Subject: Contract No. NRC-02-81-026
Benchmarking of Computer Codes and Licensing Assistance
Monthly Letter Progress Report for June 1986

Contract No. NRC-02-81-026
Benchmarking of Computer Codes

This letter is in response to a recent telephone conversation between yourself and Acres regarding the input data to Benchmark Problem 6.3 - BWIP. The Benchmark Problems Report (NUREG/CR-3636) provides the following in situ stress data:

Problem 6.3 - BWIP
Boundary and Initial
Stress Loading Conditions

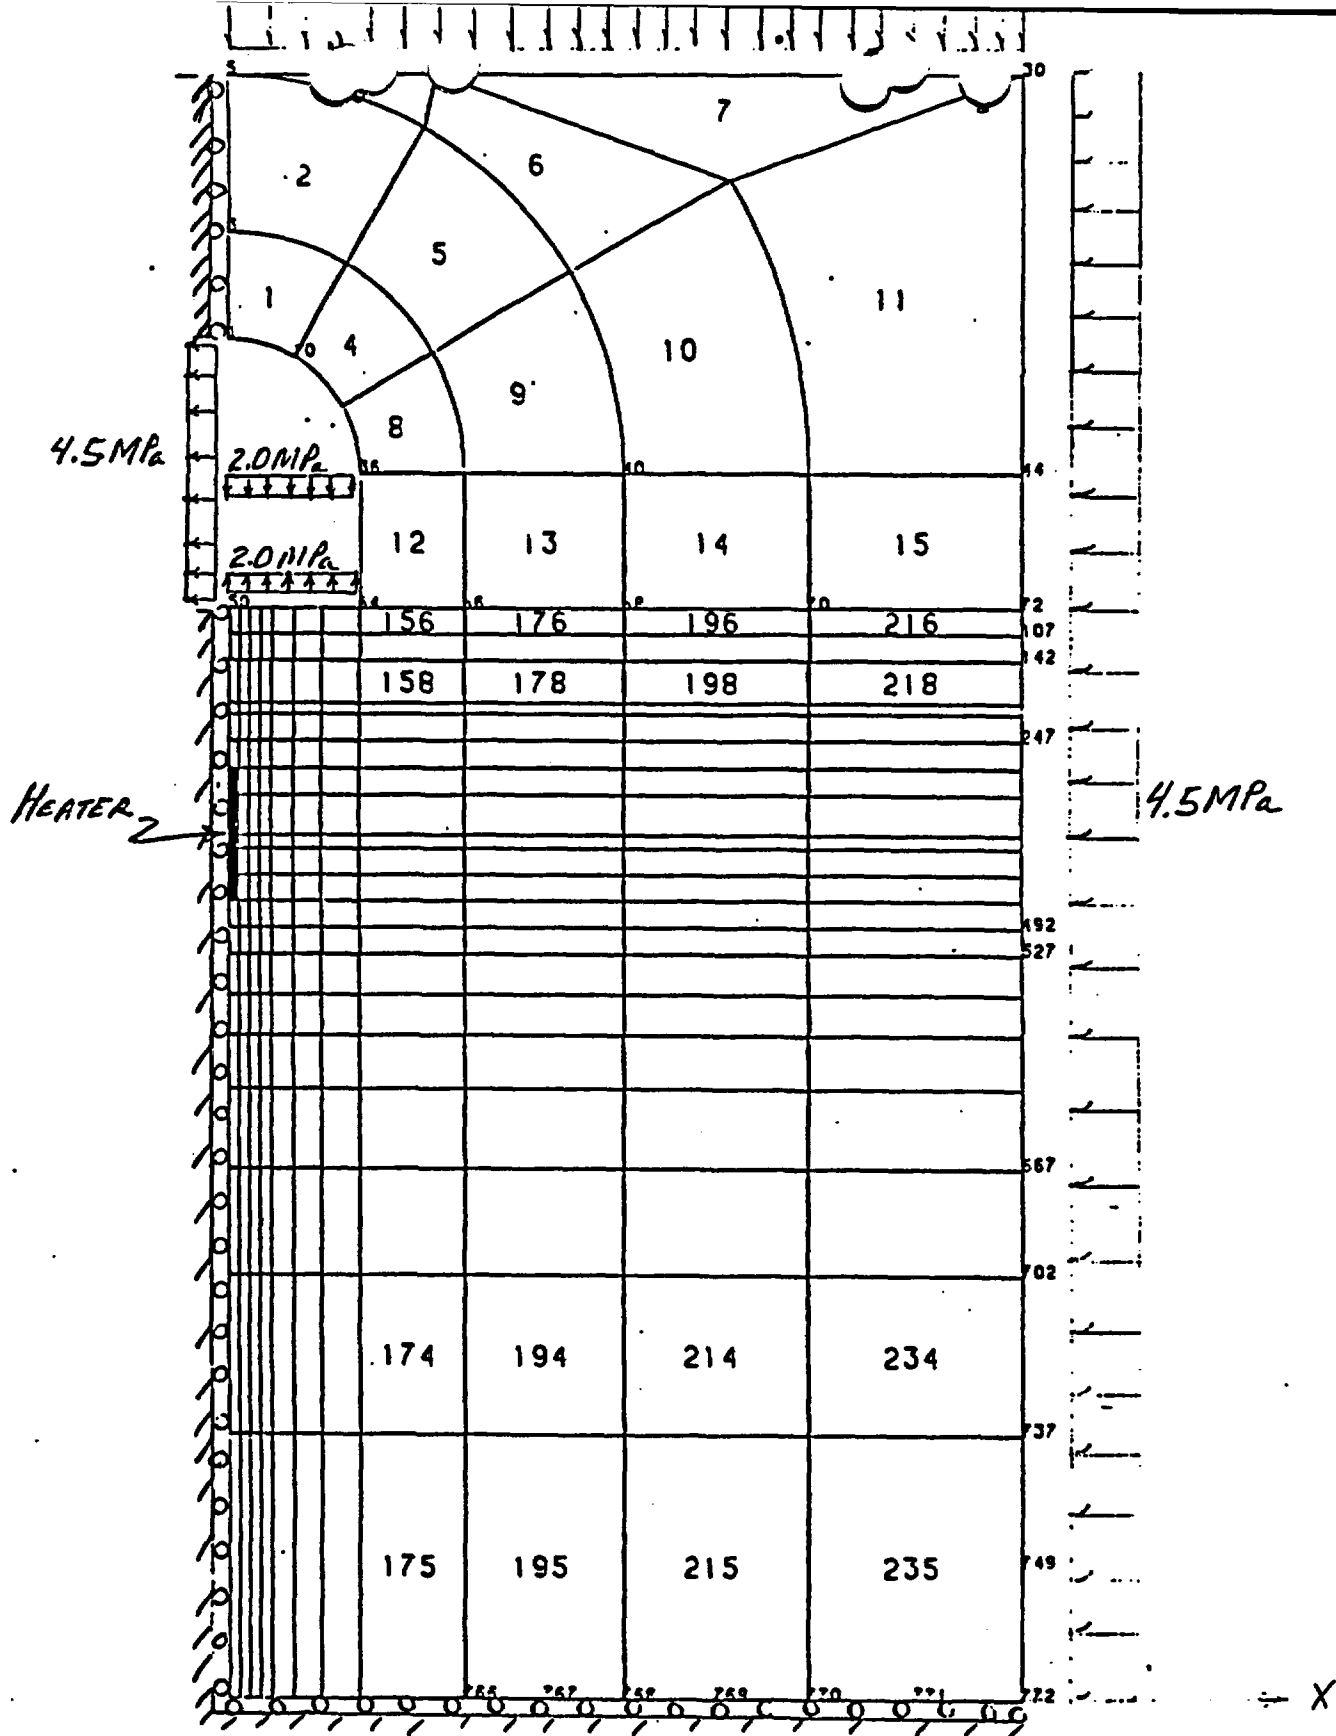
A question raised by Mr. Krishan Wahi about the in situ stress in problem 6.3 was addressed in a letter from Acres. (copy attached).

In the definition of this problem, no reference was made to the North direction. Thus the bearings given do not indicate the direction of the major stress relative to the excavation. In modeling this problem with the MATLOC and VISCOT codes, we have assumed that SIGMA₁ and SIGMA₂ act in the horizontal direction, and that SIGMA₃ acts in the vertical direction. We have further assumed that an average horizontal stress acts throughout the modeled region, with magnitude equal to $(7+2)/2 = 4.5\text{MPa}$.

The finite element mesh used in the models consisted of 8-noded axisymmetric elements and is shown on the enclosed figure. For both codes, initial runs were made to define the in situ stress state and to redistribute the stresses due to the excavation. In the initial runs, the vertical stress was applied to the top model boundary, and the horizontal stress was applied to the right-side vertical boundary. An additional loading condition was applied to account for the effects of the excavation of the room. Tensile loads, corresponding to the horizontal and vertical components of the in situ stress state were applied to the element surfaces along the excavated surface. In all runs, roller boundaries were assumed along the vertical symmetry boundary and along the bottom of the modeled region.

All of the loading and boundary conditions discussed above are shown on the enclosed figure. If you have any further questions, please let us know.
